Response to NRC's ltr dtd 02/07/78  
...Furnishing addl info on the analysis of the  
Steam Generator Subcompartment Pressure Response...  
Notorized 02/27/78...

Donald C. Cook Nuclear Plant Units 1 & 2  
Docket Nos. 50-315 and 50-316  
DPR Nos. 58 and 74  
Steam Generator Subcompartment Pressure Response Analysis

In his letter dated February 7, 1978, Mr. Kniel of the Division of Project Management requested additional information on the above cited analysis. An item by item response to Mr. Kniel's request is enclosed herein.

Figure 1. "Five Node Model."

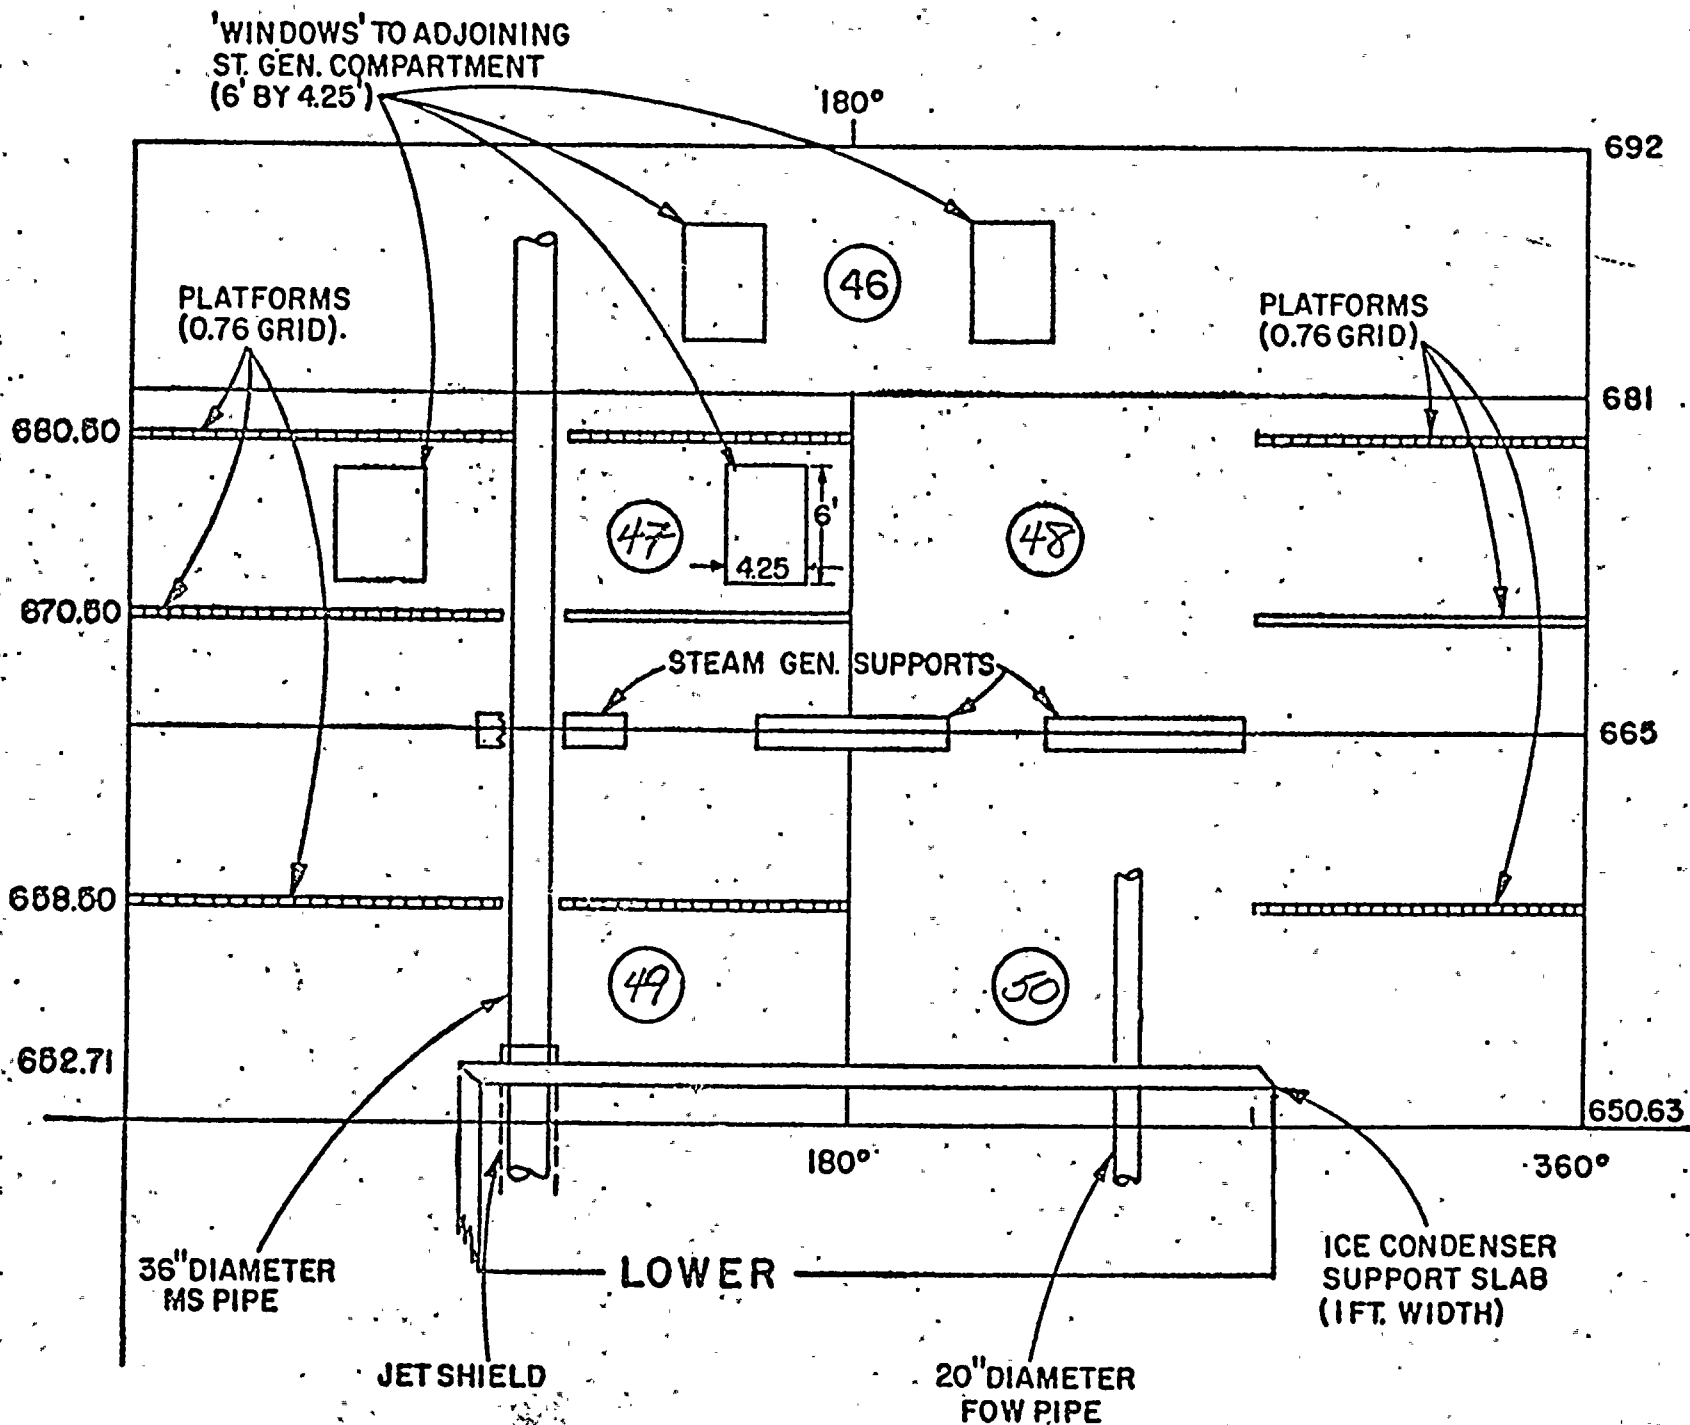
1. Provide drawings which indicate the manner in which the net free volume within the steam generator enclosure was subdivided to formulate the five node and seventeen node models which were part of the nodalization sensitivity studies.

The nodalization schemes for the five and seventeen node models are given in Fig. 1 and Fig. 2, respectively. The flow parameters used in these nodalizations are listed on the following pages.

FIGURE 2.1

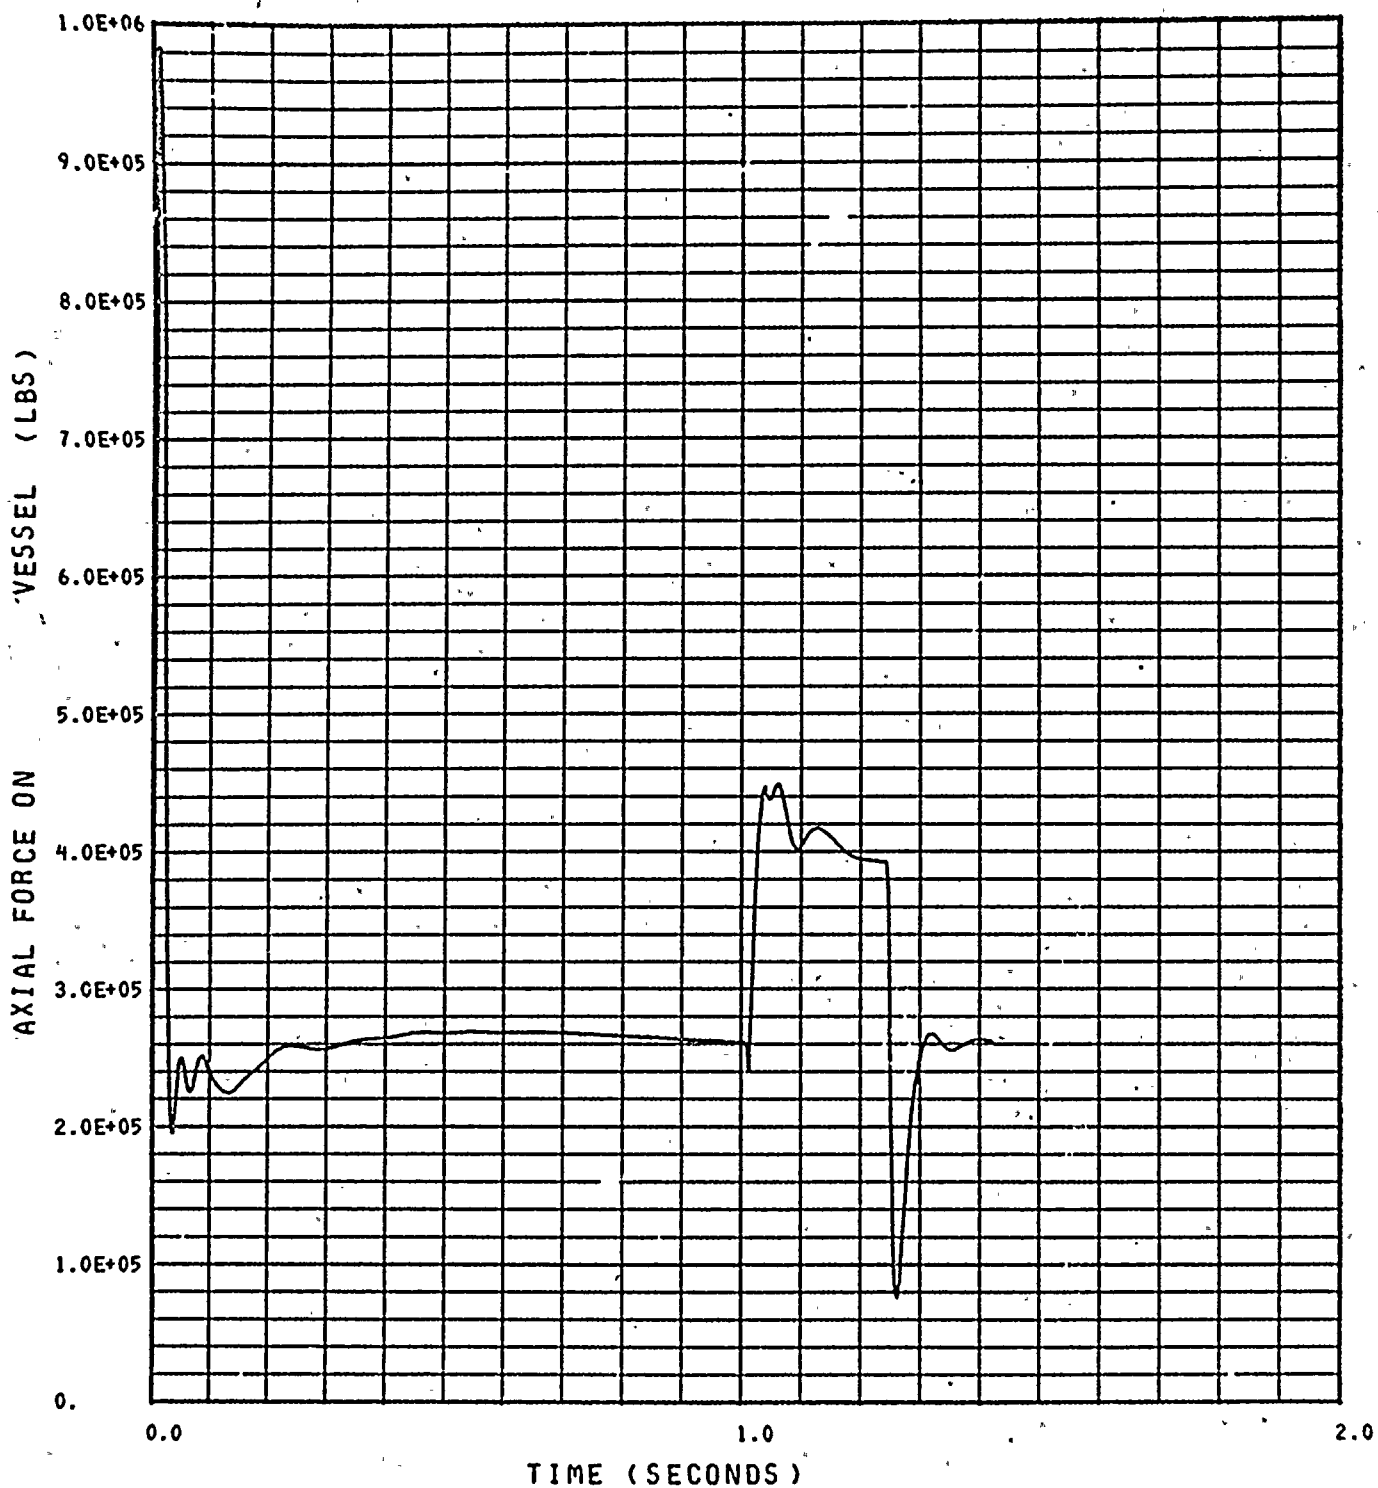
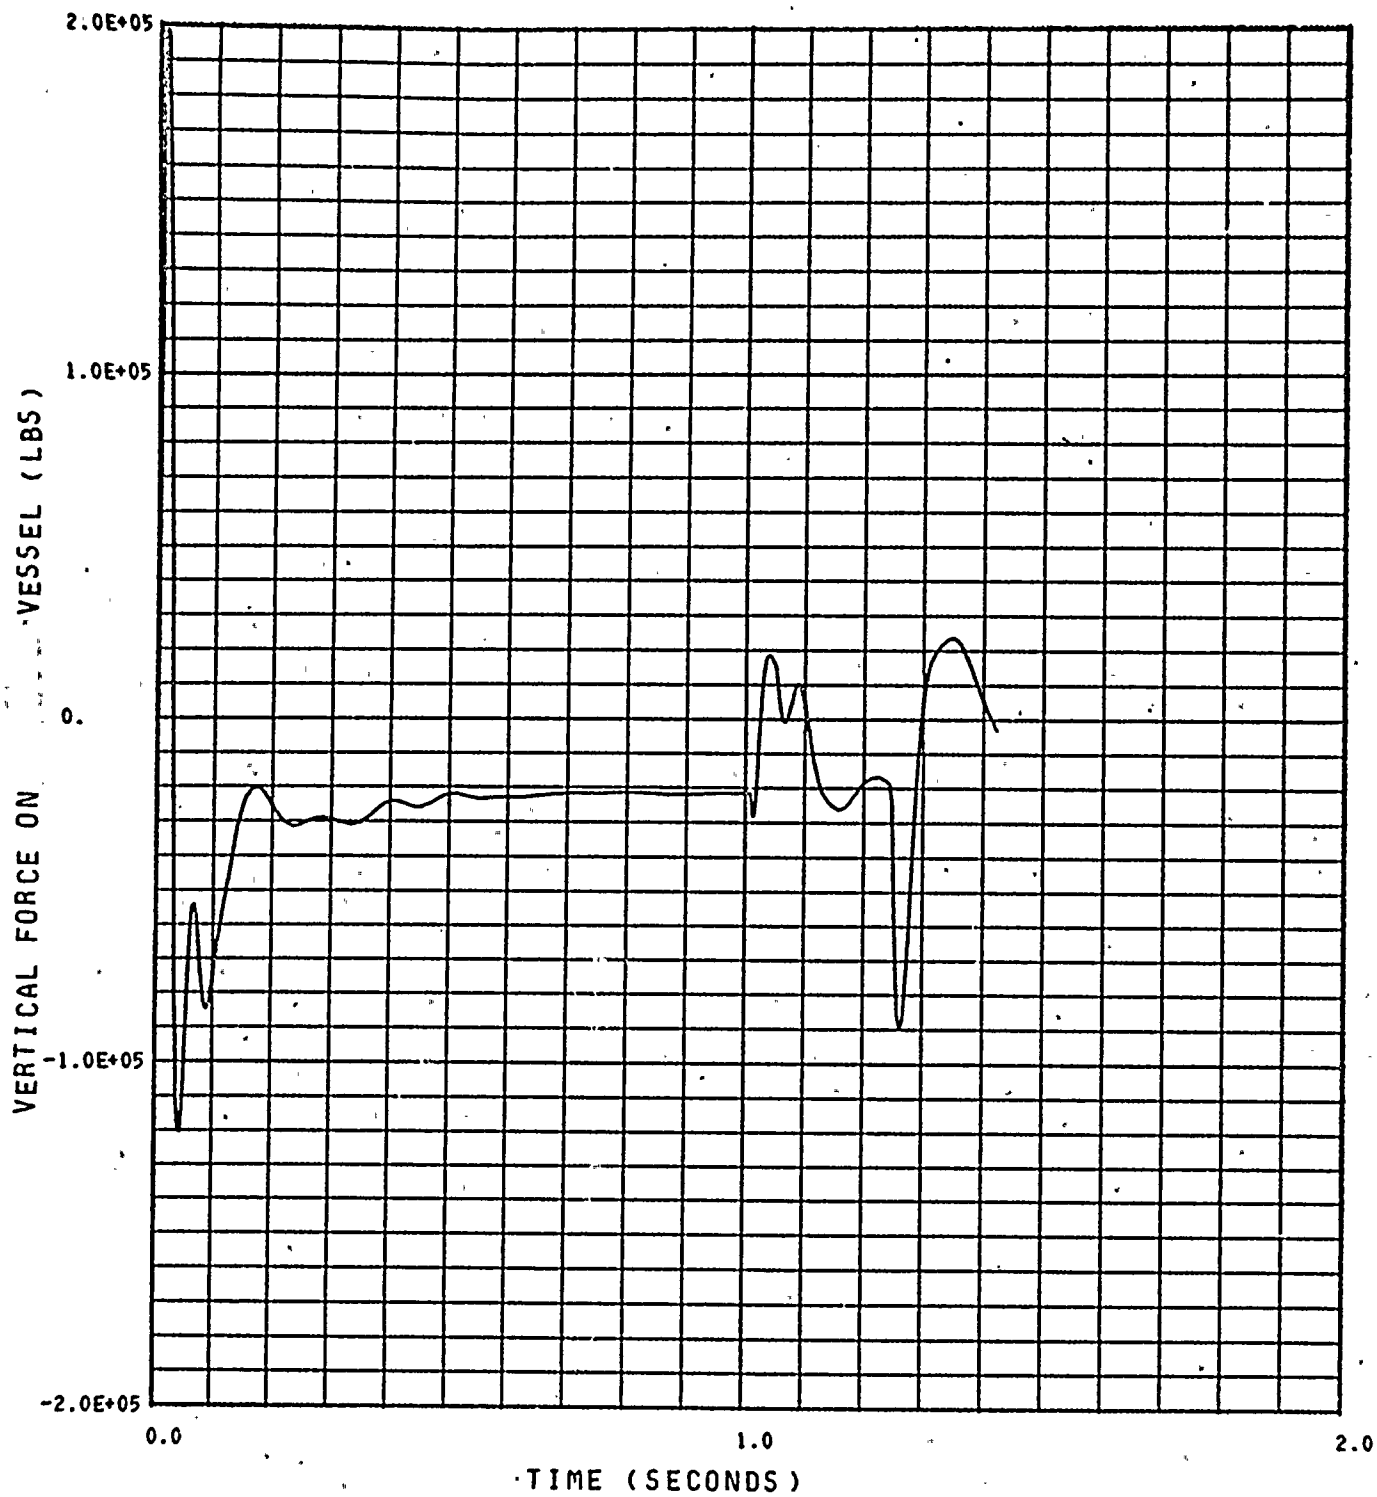
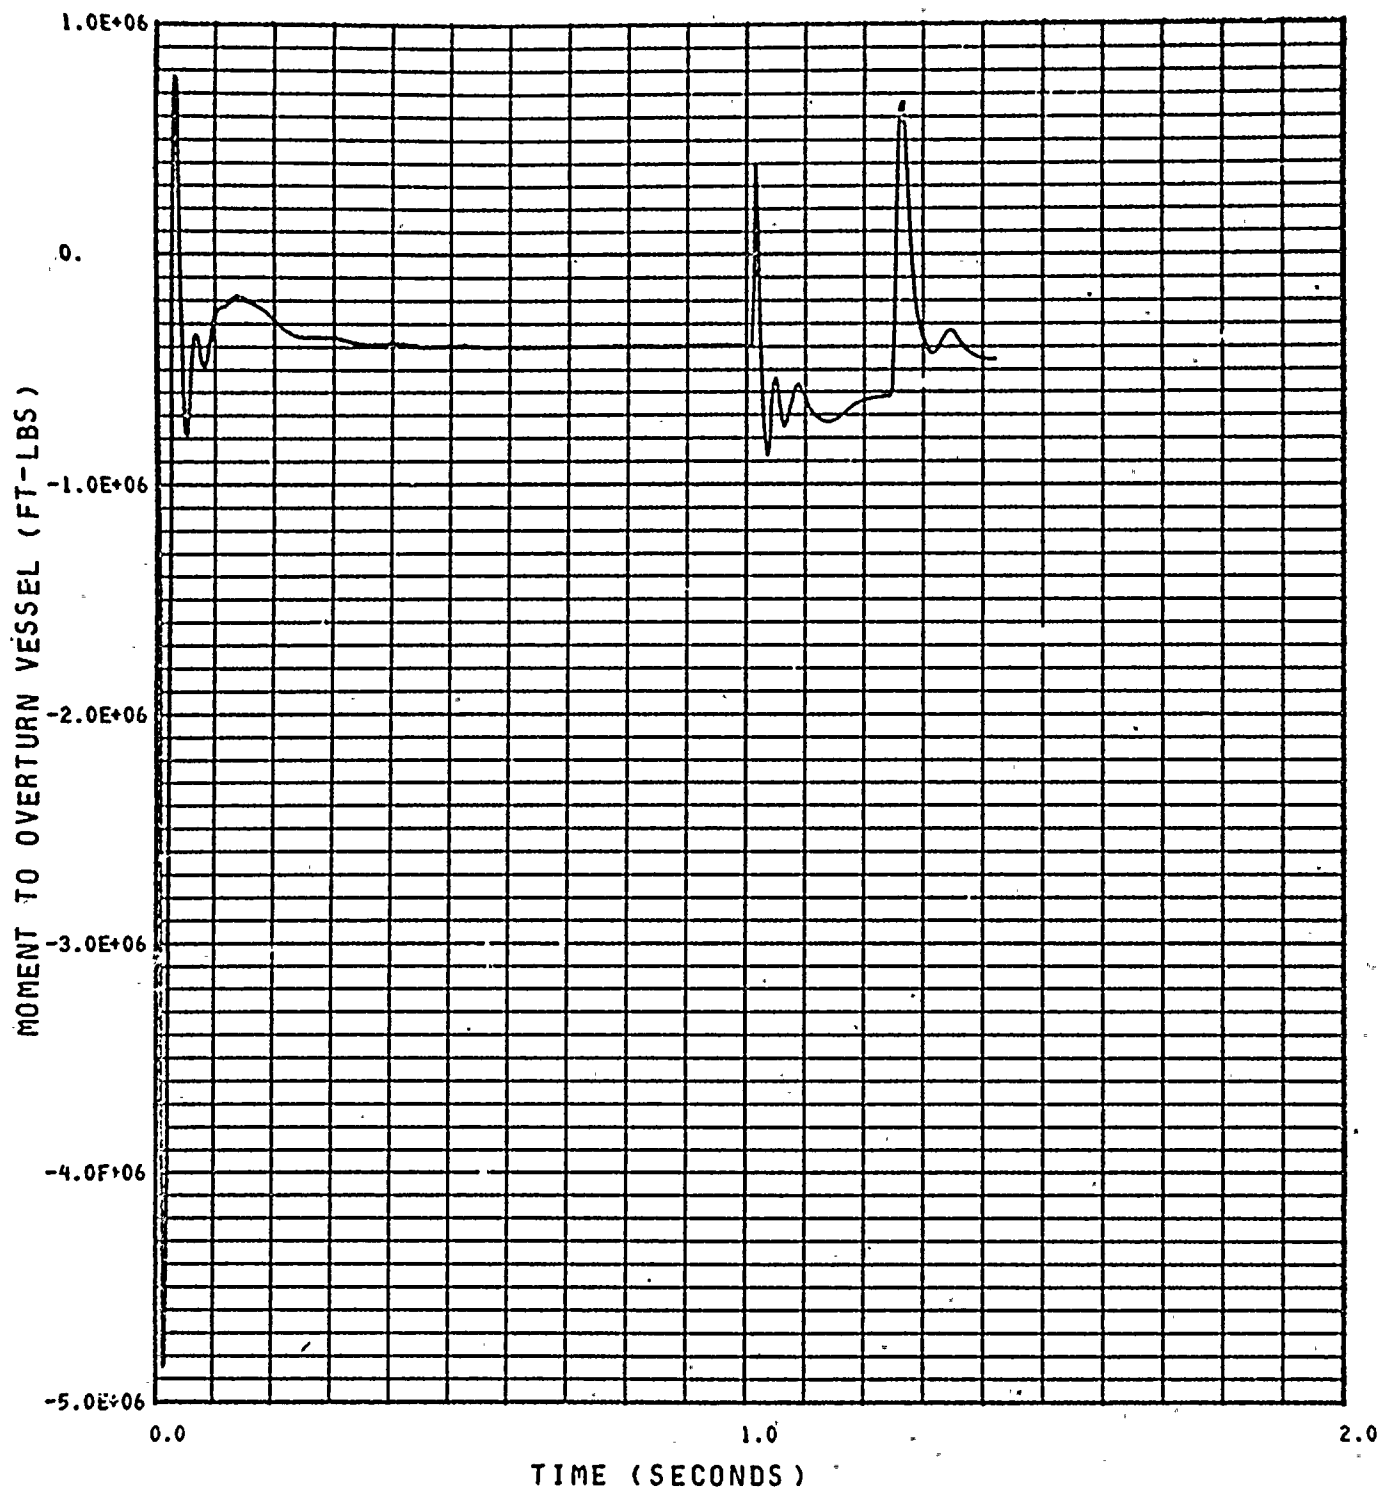
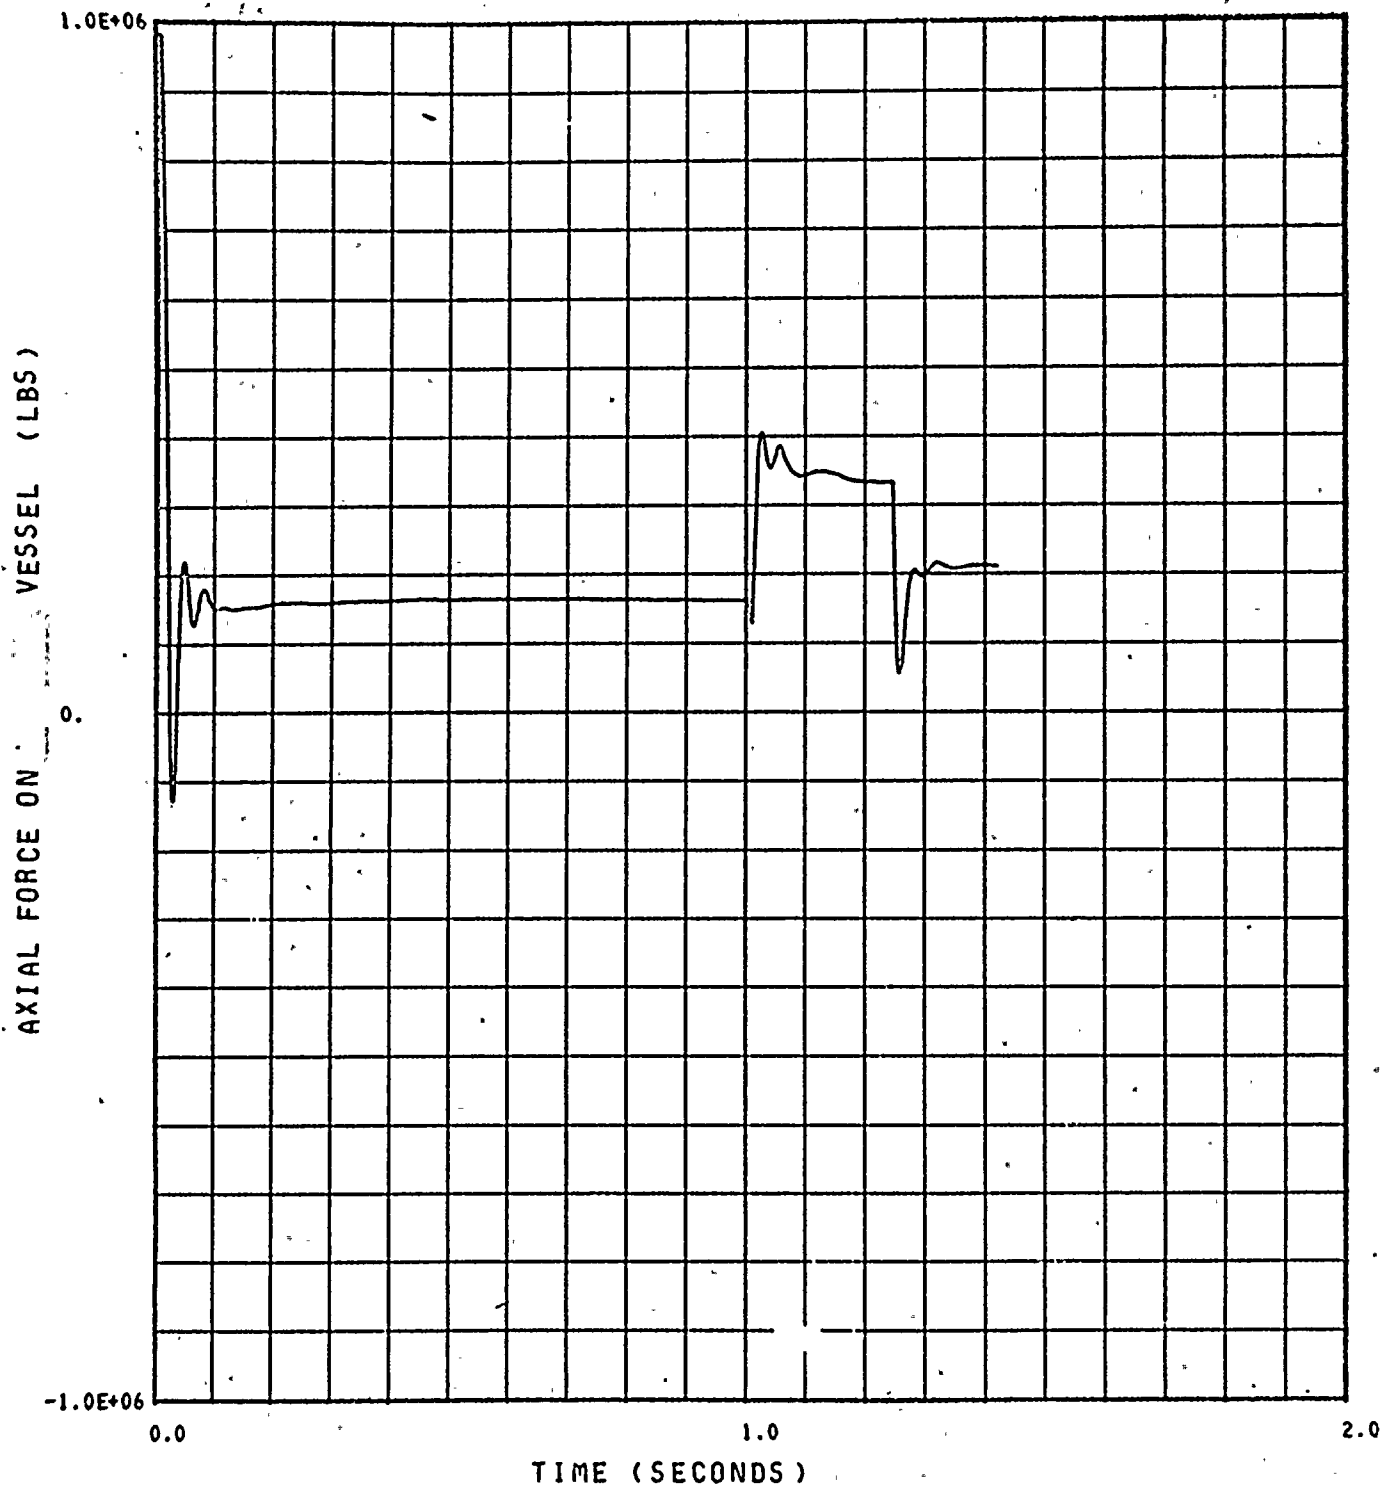
2. Provide figures which (a) identify the peak forces and moments acting upon the steam generator for each of the models used in the sensitivity studies (i.e., five, nine and seventeen node models) and (b) demonstrate that the loads transmitted to the steam generator supports are maximized by the nine node model.

- (a) Table A presents the peak steam generator loads and the time of occurrence for the five, nine and seventeen node models. Figures 2.1 through 2.9 present the horizontal (same as axial) force time history, the vertical force time history, and the moment time history for each of the three models evaluated in the nodal study.

- (b) Only the peak inertial negative moment for the five and seventeen node models were slightly higher than the peak inertial negative moment for the nine node model. The calculations of the steam generator support loads were made by combining the forces and moments without consideration of time phasing. This conservatism would result in the nine node model submitted encompassing the resultant support loads using a time phase analysis with the other 2 models. This can be seen by noting from the attached information that the peaks are quite narrow and do not occur at the same time.
